Addendum # 3

Bid Opportunity: 26-7848-RFT - Waterloo Collegiate Institute HVAC and Exterior Upgrades Phase 2

SCALE	DRAWING NUMBER
As indicated	
SHEET SIZE: 609 x 914	A5.2
PROJECT NUMBER: 2025-153

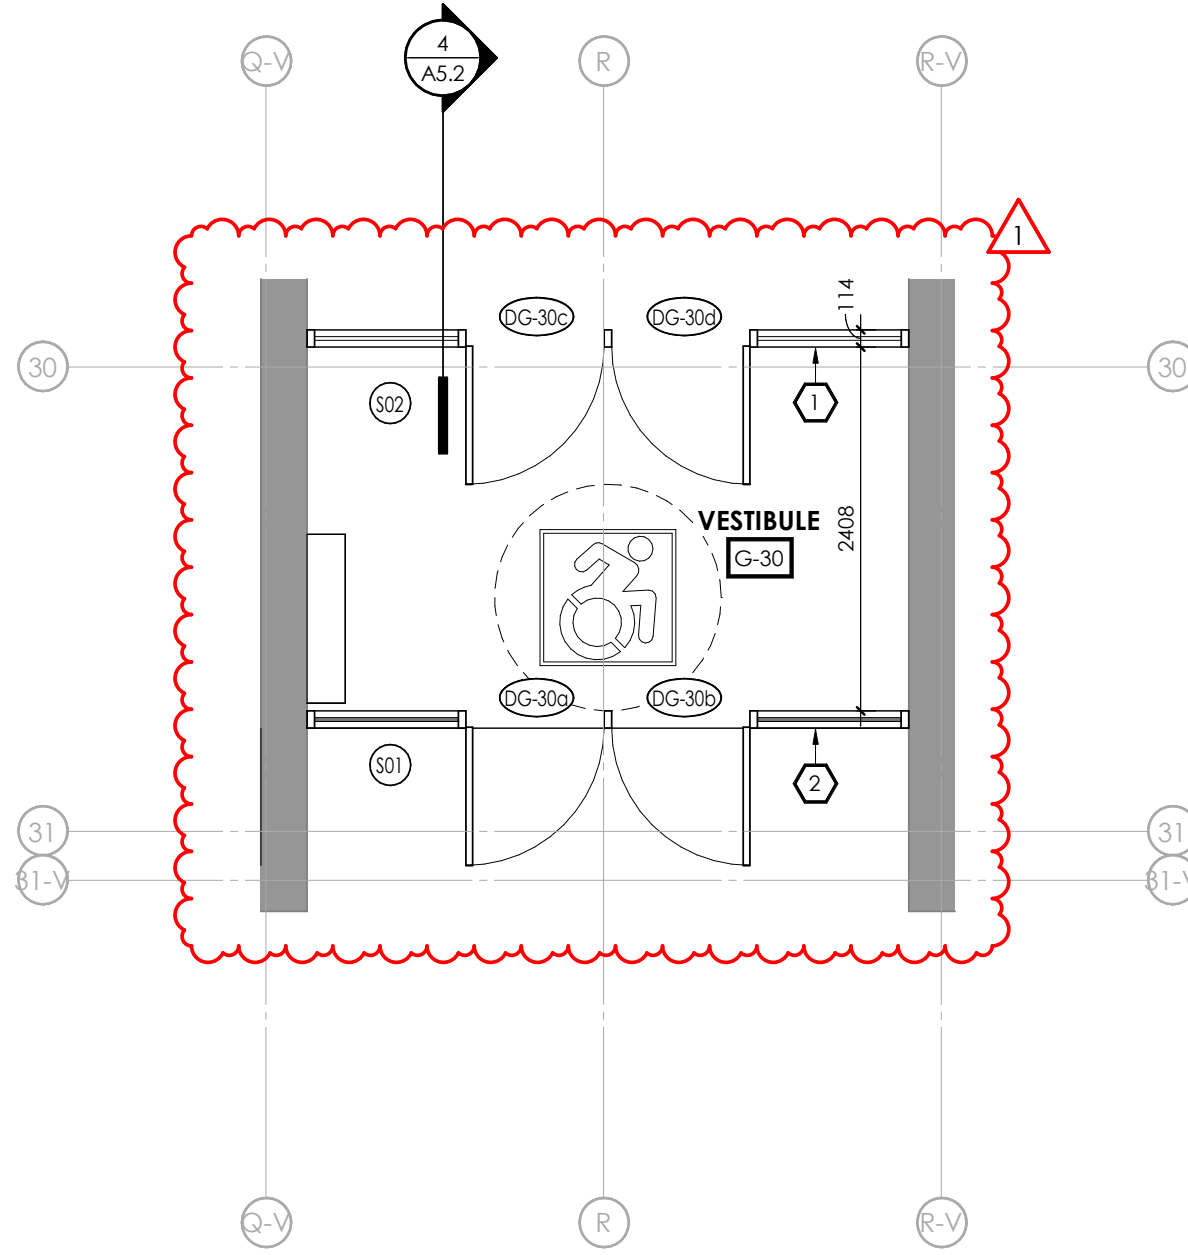
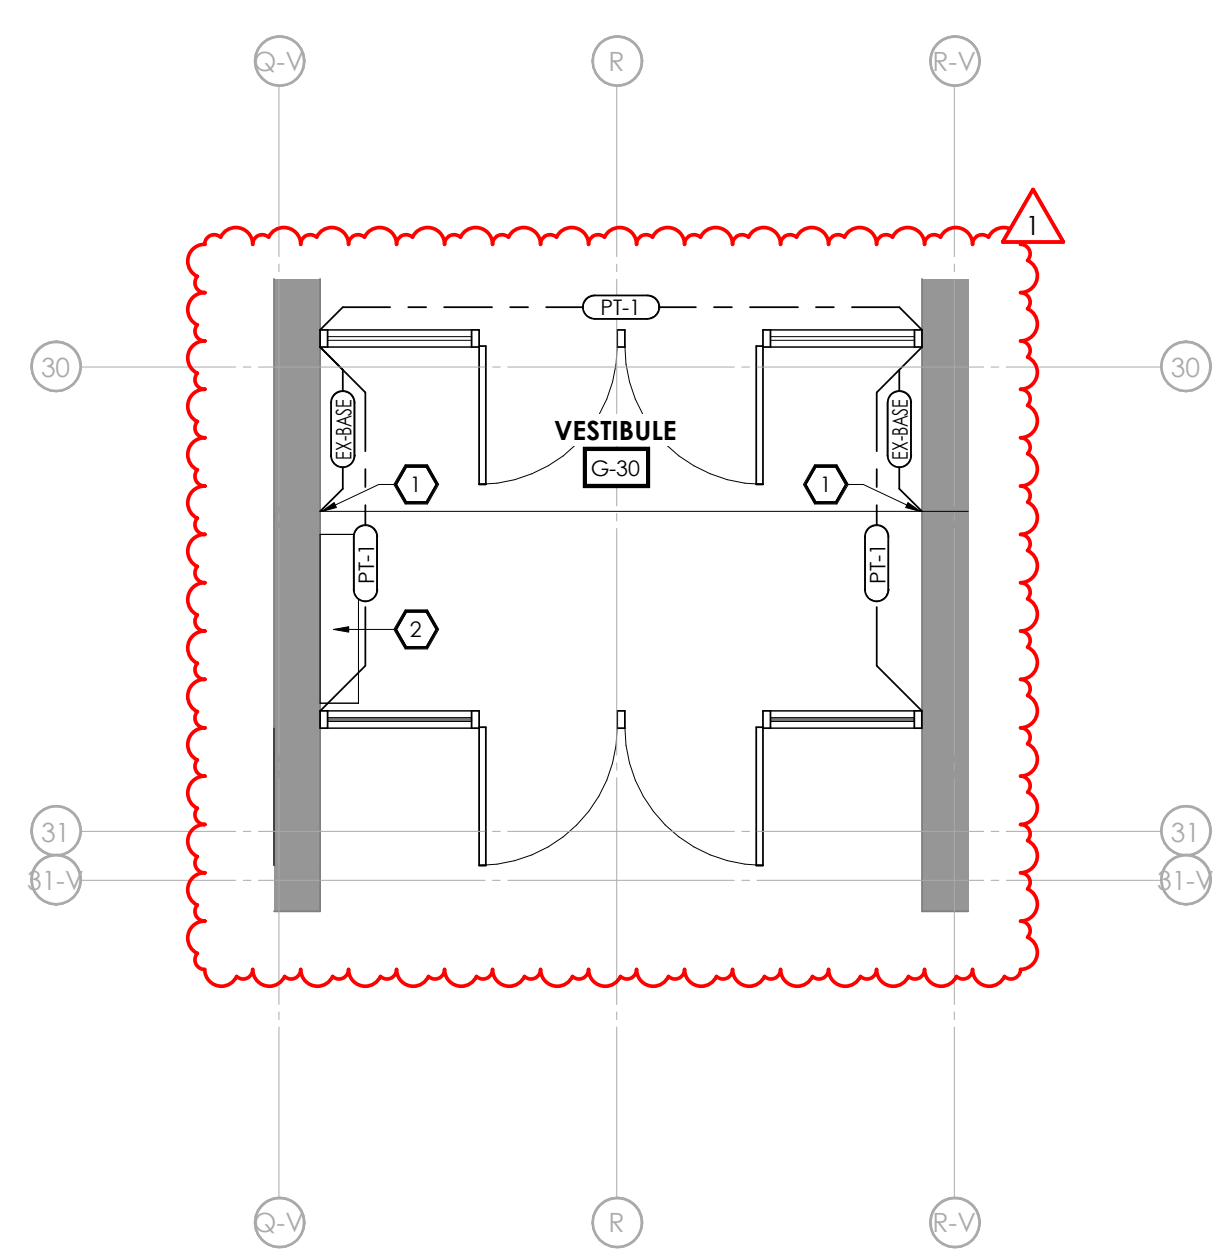
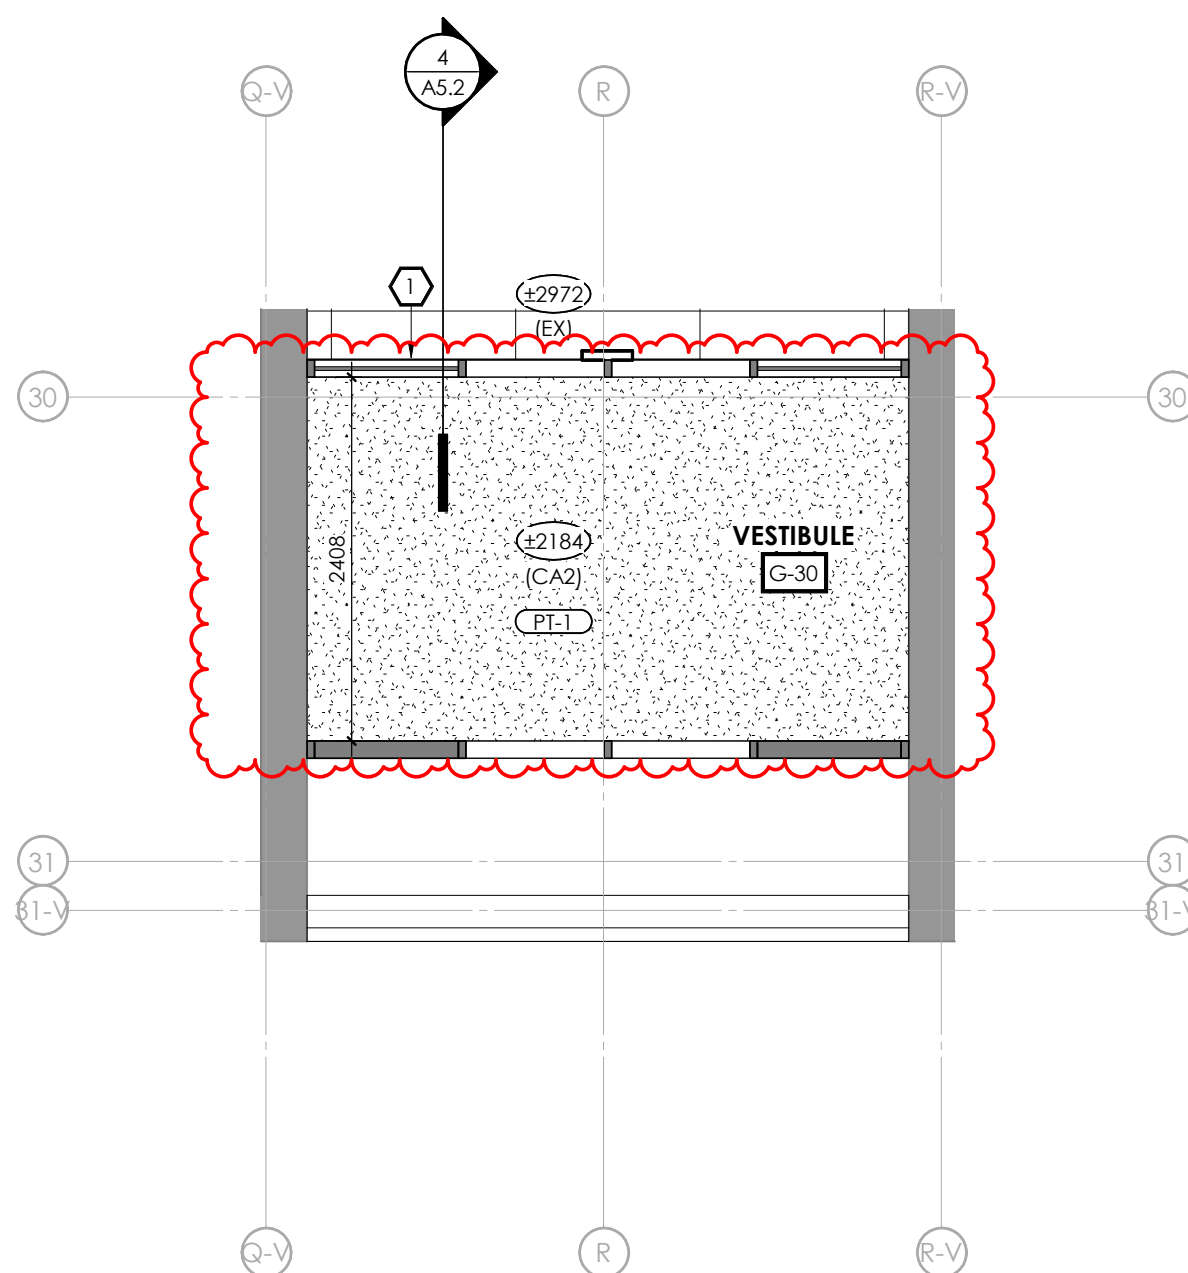
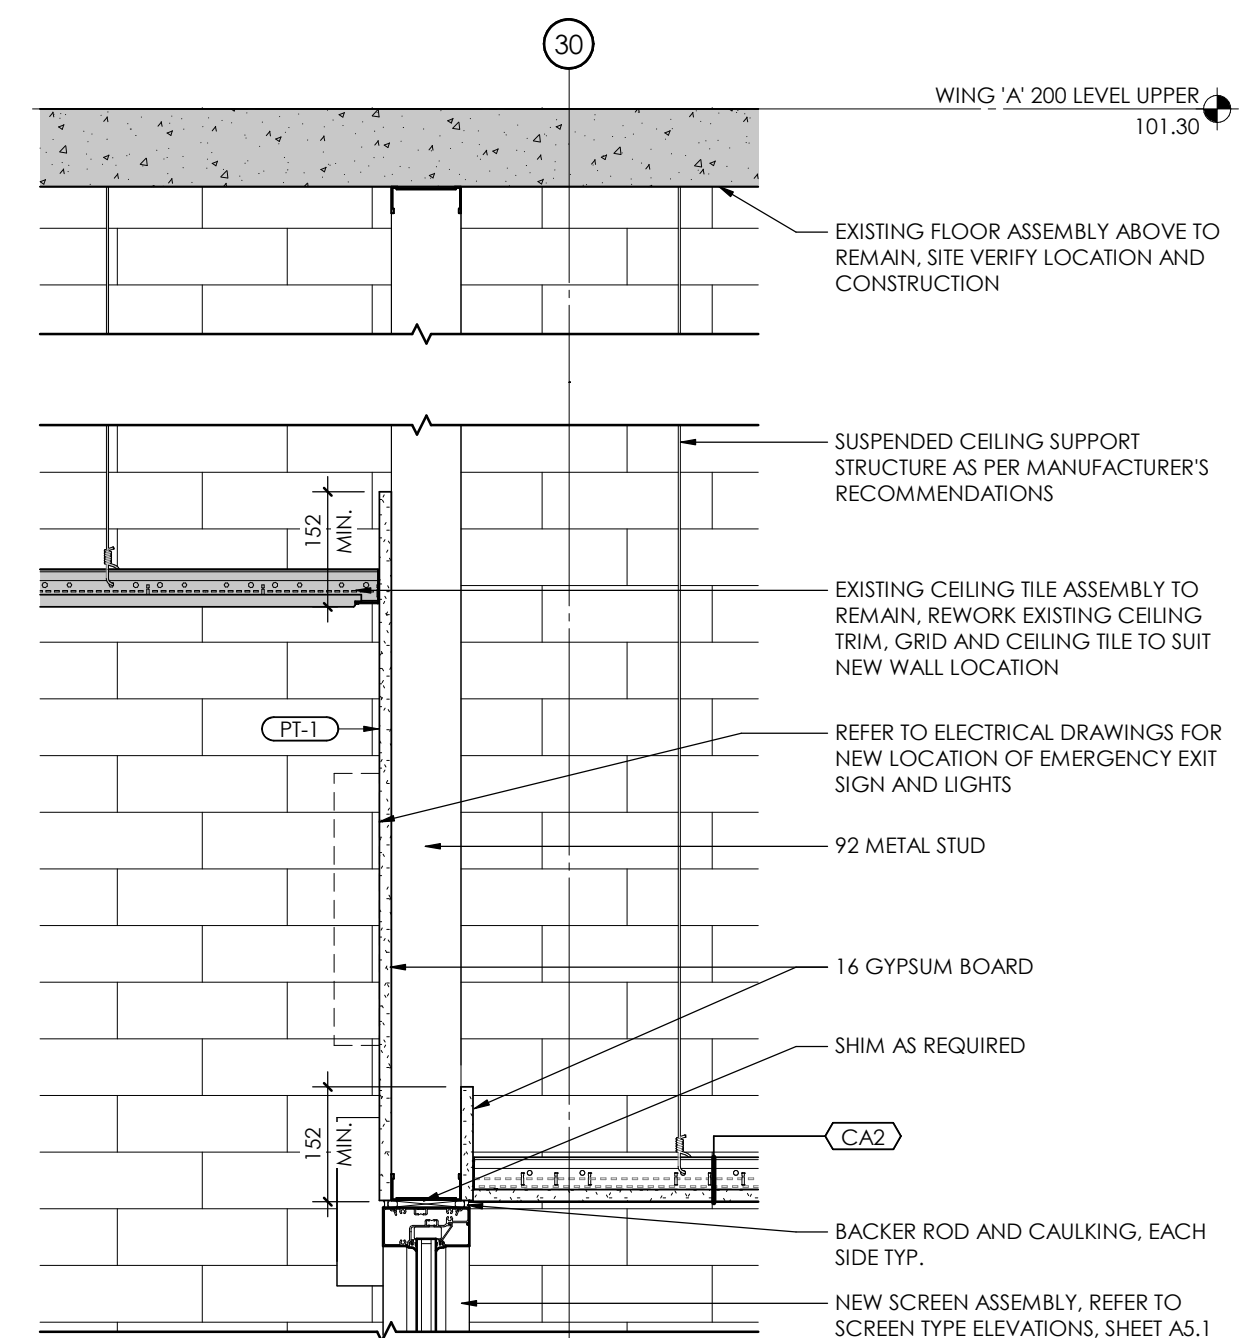
On A5.1 demo note D2 says to keep the existing ceiling. This is an old plaster ceiling that is already partially damaged.

Due to the absence of a detailed specification for the thermally broken storefront system indicated on drawing S01/ A5.2, please reference a thermally broken system of performance equivalent to the 451UT series to maintain continuity with the building envelope's high-performance thermal requirements, or approved equivalent.

Refer to Sheet A5.1 and A5.2 dated 2026.03.23, attached, and forming part of this addendum.

- ### FINISH PLAN KEYNOTES
- 1 FINAL WALL CONDITION TO BE CONFIRMED FOLLOWING REMOVAL OF EXISTING SCREEN ASSEMBLY. WALL BASE TERMINATION TO BE INSTALLED AT EXTENT OF EXISTING WALL BASE. IF UNABLE TO COMPLETELY REMOVE CAULKING, ALTERNATIVE 152 WIDE ANODIZED ALUMINUM PLATE TO BE INSTALLED OVER TRANSITION BETWEEN BRICK AND CONCRETE BLOCK, ENSURING CAULKING AND WALL BLEMISHES ARE COVERED. SITE VERIFY AND COORDINATE WITH OWNER.
 - 2 EXISTING RADIATOR COVER TO RECEIVE NEW PAINT FINISH TO MATCH NEW WALL PAINT FINISH.
